3 April 2025

Our Ref: SSD-2025/1
Our Contact: Robert McKinlay (02) 9366 3724

RE: Response to Request for Advice – Environmental Impact Statement: 49-61 Stephen Road, Banksmeadow – Multi-Level Warehouse

Figure 2: Office Sections - Extract from Office Section A of Appendix F Architectural Plans
(Source: Architectural Plans, SBA)

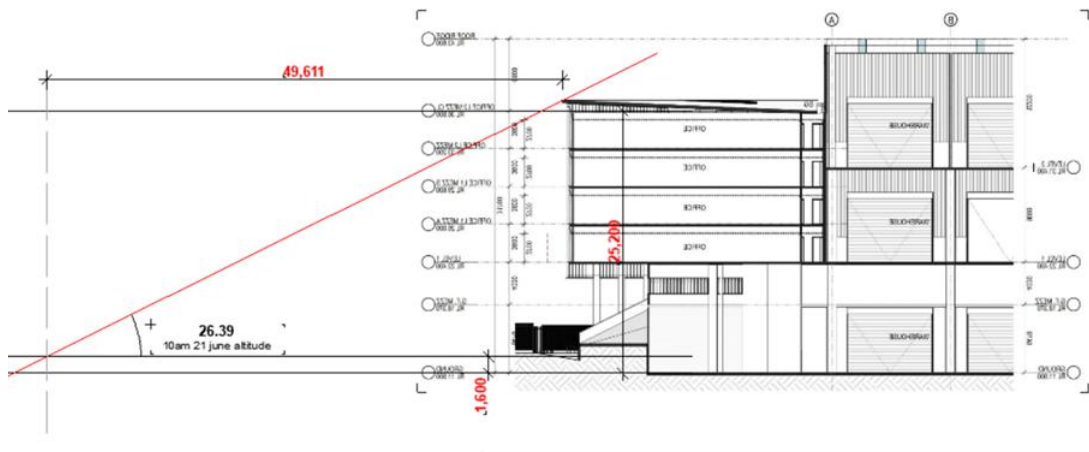
A review of the solar analysis and shadow diagrams provided in the Design Report, prepared by SBA (dated 18 November 2024), appears to show some discrepancies in depicting the extent of shadow cast over Stephen Road. The section in **Figure 2** shows the shadow cast at 10AM, mid-winter as being approximately 49.6 metres in length. This is approximately 10 metres longer than the shadow shown on Page 30 of the Design Report (**Figure 3**).

It is also noted that the position of residential dwellings depicted on shadow diagrams are not included in the survey drawing provided. Further information is required to clearly and accurately demonstrate the extent of overshadowing to existing residential dwelling on the western side of Stephen Road.

Figure 4: Concept Design – used in pre-lodgement consultation and in requesting SEARs (Source: SBA)

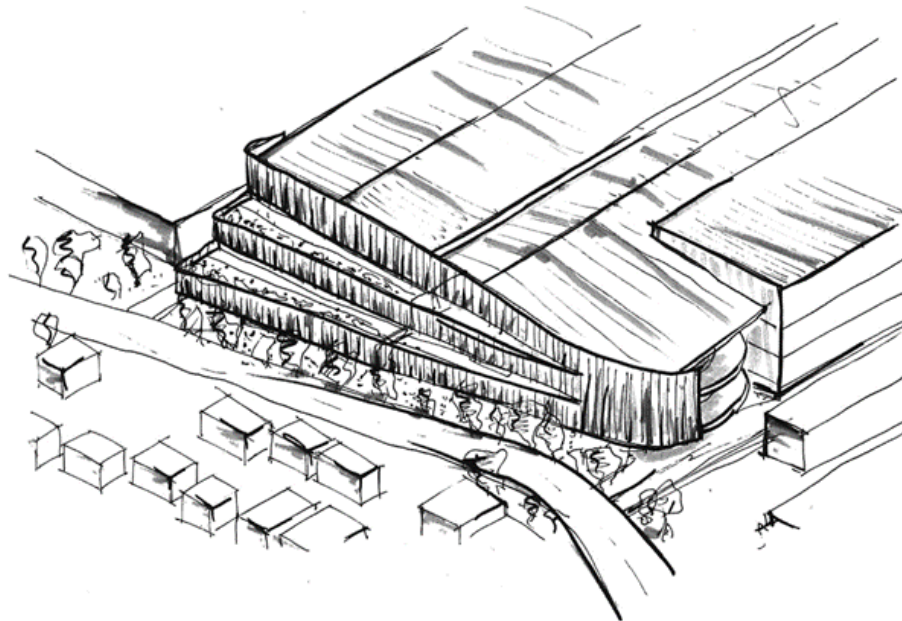
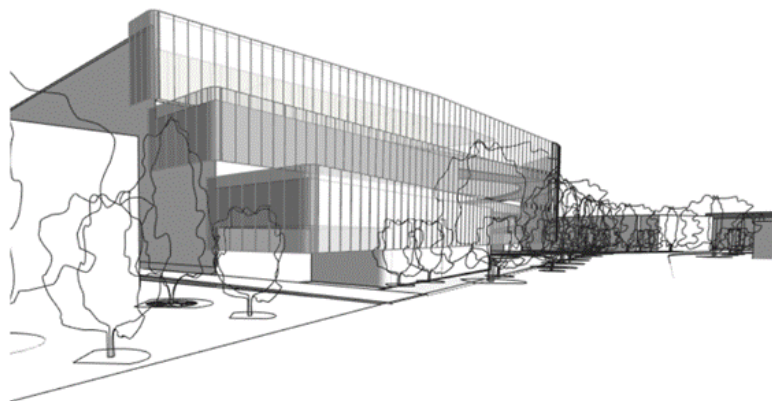
The proposed scheme includes departure from the design proposed in the Scoping Report at the SEARs stage regarding the transition to the Stephen Road frontage including a stepped setback design (see **Figure 4** below). A stepped setback building frontage could provide a gentler transition and address other concerns stated above.

Figure 5: Excerpt of outdoor staff amenity area (in Red) in Landscape Master Plan
(Source: Landscape Plans, Geoscapes)

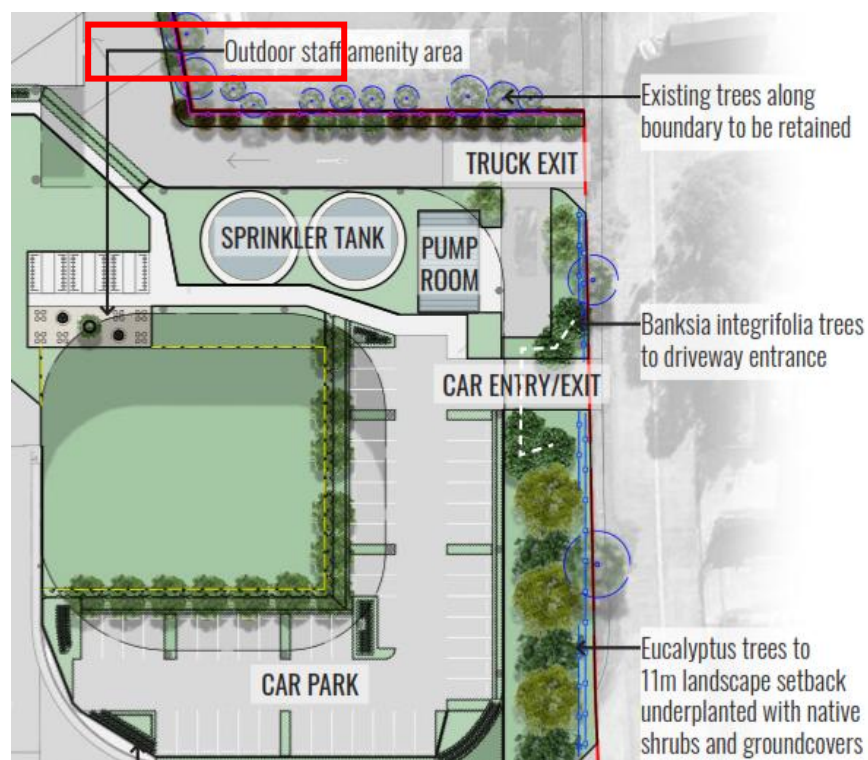
The outdoor staff recreation area controls in Section 6.4 Industrial Premises of the BDCP 2022 state that outdoor staff recreation areas should be designed to receive direct sunlight for the four hours between 10am and 2pm during mid-winter as well as provide shading in the summer.

The proposed outdoor staff amenity area in the Landscape Master Plan (**Figure 5**) is located towards the southeast of the site and is not favourable for use as it is shaded from the sun due to being underneath and surrounded by the elevated truck ramps. This will also result in excessive noise from circulating trucks. Some plans also show the adjacent grassed area within the ramp being used for stormwater detention which could create amenity or safety issues for staff in the adjacent outdoor space.

A more suitable outdoor staff area shall be provided, preferably in an east or north-facing location, to improve usability of the space.

Figure 8: Figure 2 from the Green Travel Plan which shows the wrong site in a different LGA.

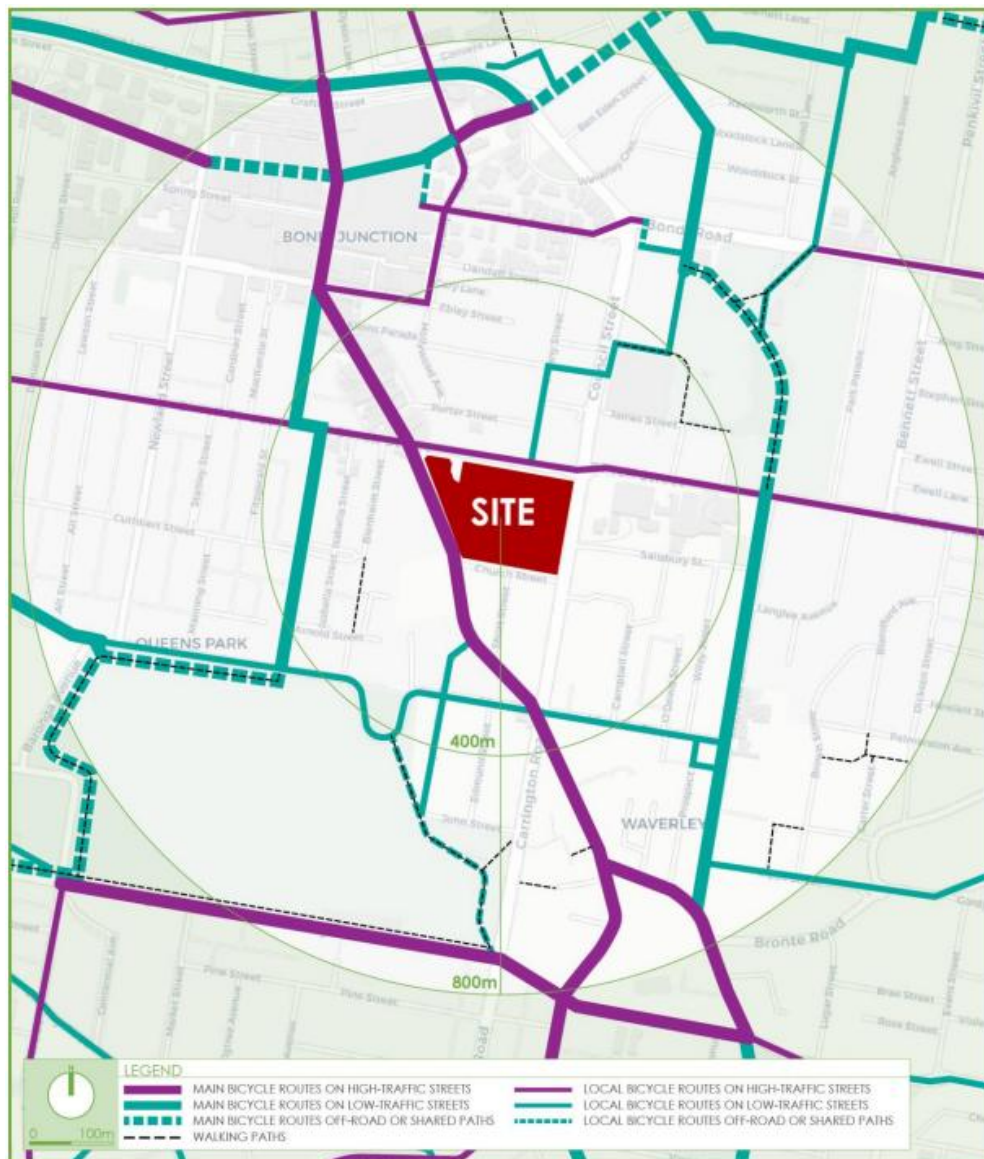
Figure 2 in the Green Travel Plan (shown below, **Figure 8**) is incorrect and shows a site in Waverly near Bondi Junction. Please correct this image and note the route detail in the Bayside Bike Plan 2024 and actions to advocate for use of the cycleway when complete.
